Riley Purgatory Bluff Creek Watershed District Permit Application Review

Permit No: 2024-003

Applicant: Asian Plaza Property LLC, Amor Zhao
Consultant: Elliott Design Build, Lance Elliott
Project: Asian Mall Parking Expansion – The applicant proposes the expansion of an existing parking lot associated with the Asian Mall in Eden Prairie, conversion of the existing stormwater pond to a subsurface stormwater facility, along with addition of two StormFilter manufactured treatment devices and a second underground stormwater facility to provide volume control, water quality, and rate control.
Location: The existing parking lot of the Asian Mall at 12160 Technology Dr, Eden Prairie, MN
Reviewer: Scott Sobiech, P.E., Barr Engineering

DRAWING TITLE
GRADING & EROSION
CONTROL PLAN

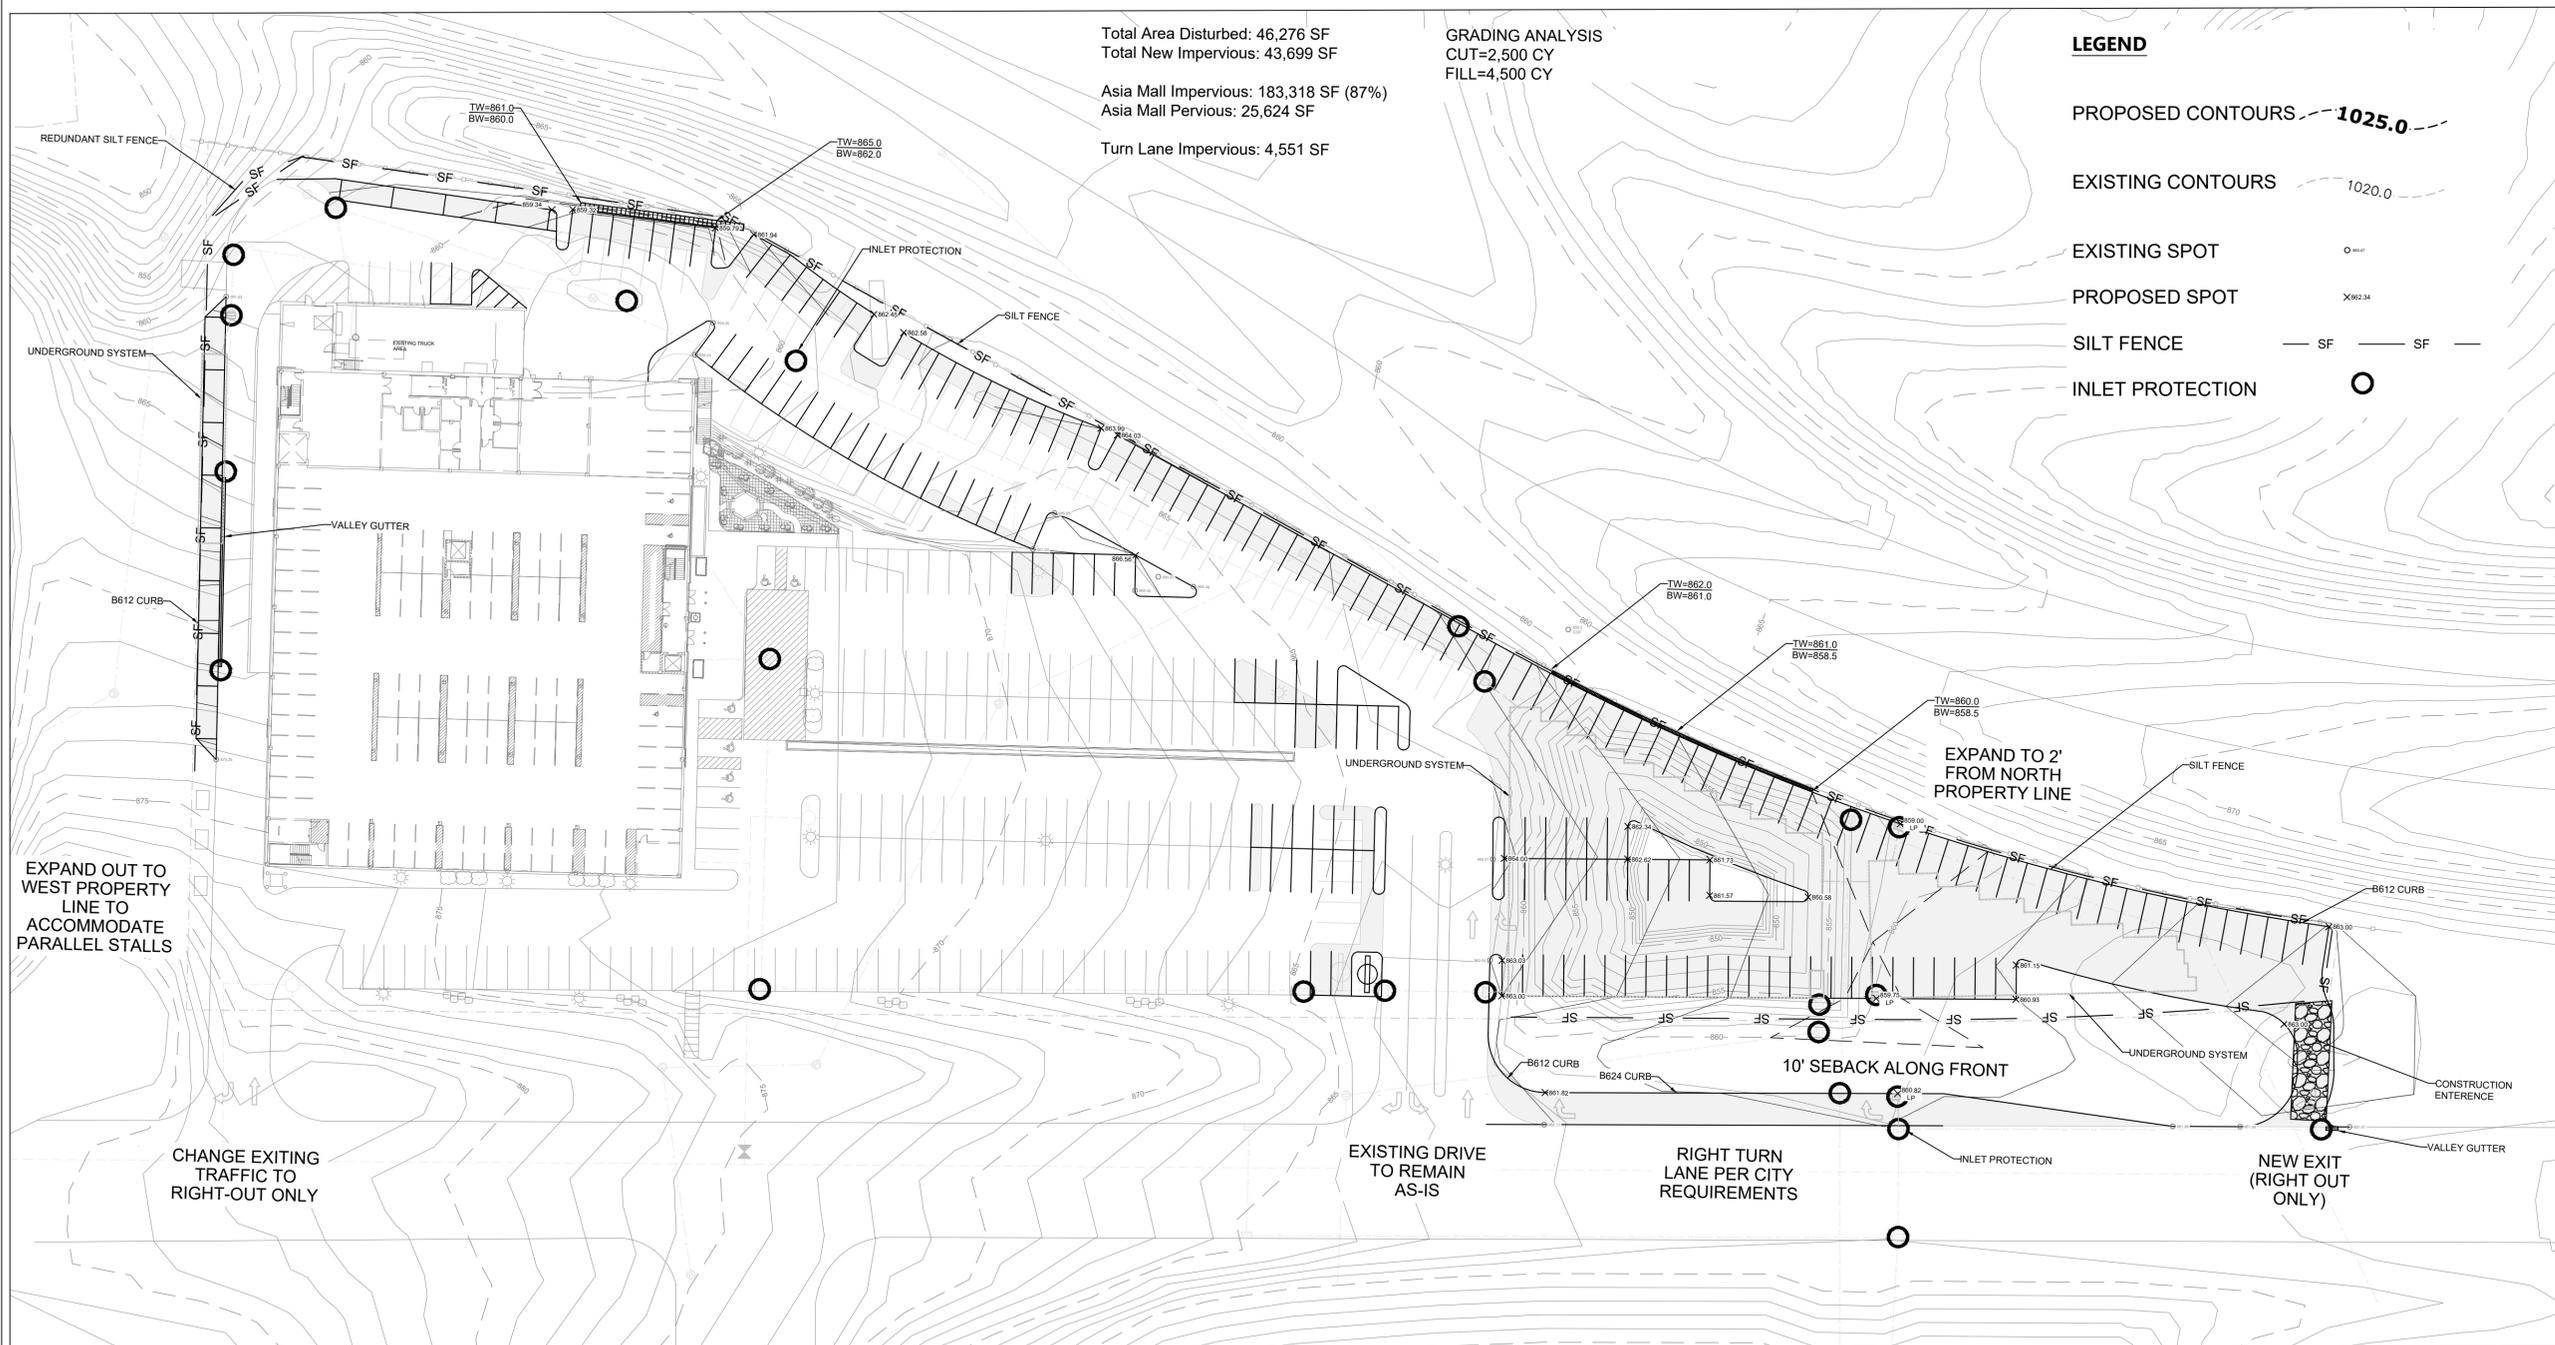
The erosion and sediment control plans prepared by Elliott Desing Build. include installation of silt fence, rock construction entrance, erosion control blanket, inlet protection, placement of a minimum of 6 inches of topsoil (at 5% organic matter), construction sequencing, decompaction of pervious areas compacted during construction, and retention of native topsoil onsite. To conform to RPBCWD Rule C requirements the following revisions are needed:

- C1. The applicant must provide the name, address and phone number of the individual who will remain responsible for performance under this rule and maintenance of erosion and sediment-control measures from the time the permitted activities commence until vegetative cover is established.
